IG1 Relay Freezing

Service Category Power Source/Network

Section Networking

YEAR(S)	MODEL(S)	ADDITIONAL INFORMATION
2006 – 2009	Corolla, Highlander, Matrix, Prius, RAV4, Sienna

Figure 1.

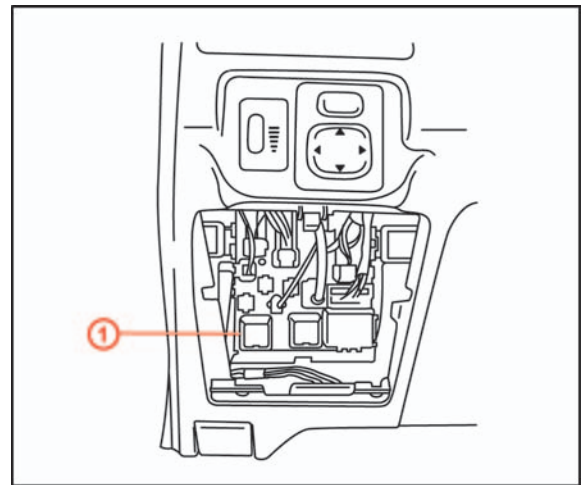
1. Locate the instrument panel junction block No. 1 in the Instrument Panel (as shown in Figure 1).
2. Remove the relay and verify the part number located on the side of the relay.
 - A. If the part number is 90987-02025 or 90987-02030, replace the relay with the countermeasure relay P/N 90987-02031.
 - B. If the part number is 90987-02031, then diagnose the specific conditions reported by the customer following the Repair Manual.
